Council Reference: REQ 08939/2022
Albion Park Quarry (Cleary Bros.) – Stage 7 expansion (SSD - 10369)
Lots 1 & 7 DP3709, Dunster Lane, Croom

Thank you for the chance to provide further advice on SSD-10369. Council technical officers have reviewed the documentation provided on the Major Projects website with regard to the State Significant Development 10369 and can provide the following comments from Council.

Figure 1 - LEP 2013 Zoning Map

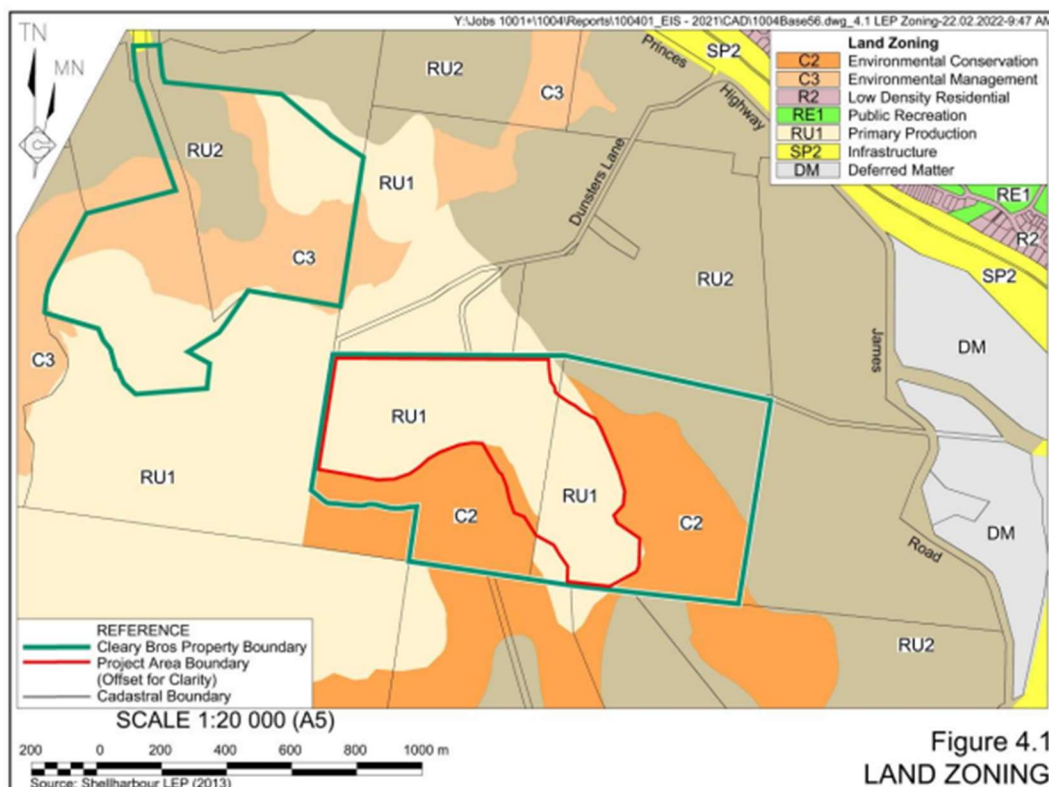
The subject land includes land within the RU1 zone and C3 zone, detailed below in Figure 1:

The subject land which extends slightly into the C2 zone along its western edge. As shown in the aerial overlay to the zoning boundary, the area affected is minor (estimated at less than 1ha) and is mostly cleared. Following completion of the quarrying activities, rehabilitation of the site will ensure that the ecological values of this affected land are gradually restored.

Figure 2 - Heritage Items Location Map

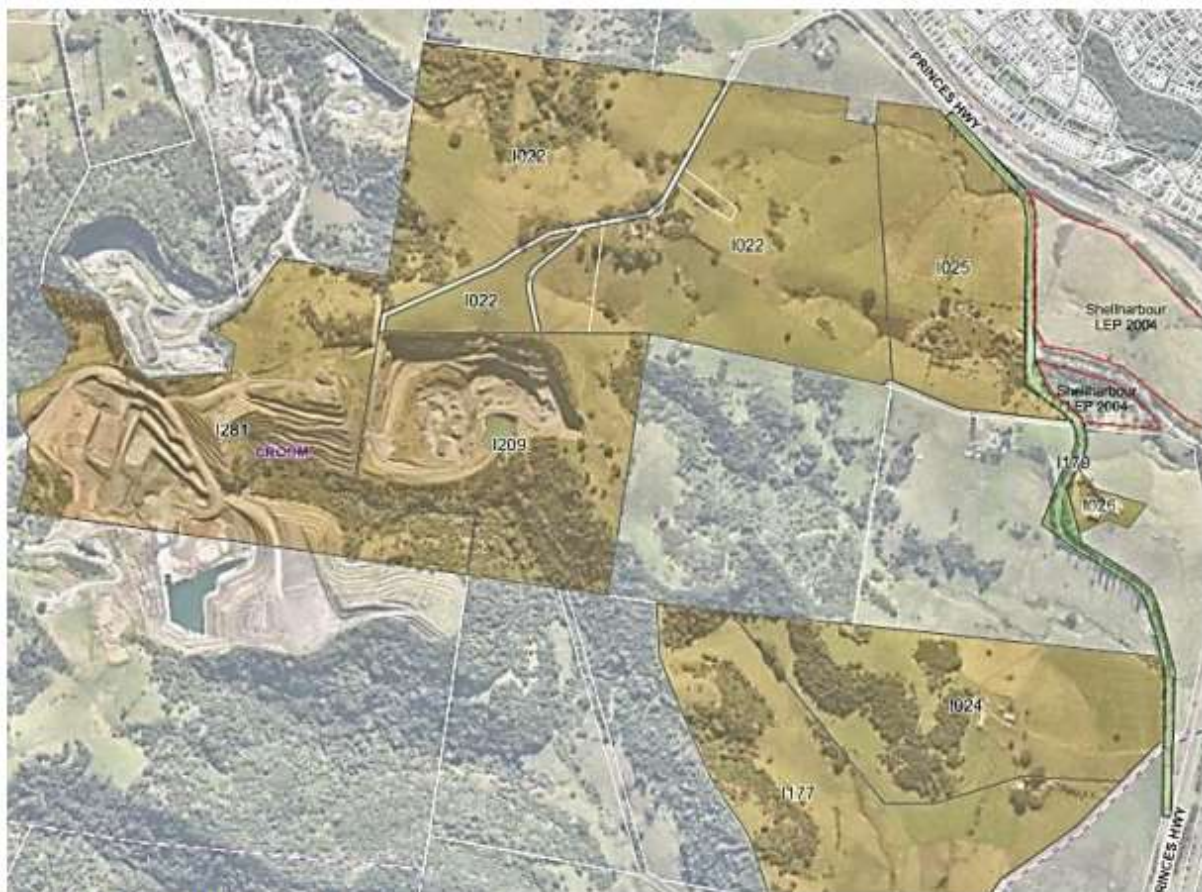
The subject property is in the vicinity of several heritage items listed in Schedule 5 of Shellharbour Local Environmental Plan 2013 described below and as shown on figure 2 below.

The heritage significance of heritage item I209 will be lost due to loss of all significant fabric. The setting and view of heritage item I022 will be adversely impacted by the proposal. The heritage significance of the Croom and Dunmore cultural landscape as defined by heritage items I209, I022, I281, I177, I024 and I025 will not be conserved or protected by the proposed development.

Council recommends that Heritage Management Plan is updated as part of the EIS and not subject to condition to allow suitable assessment and review to be carried out.
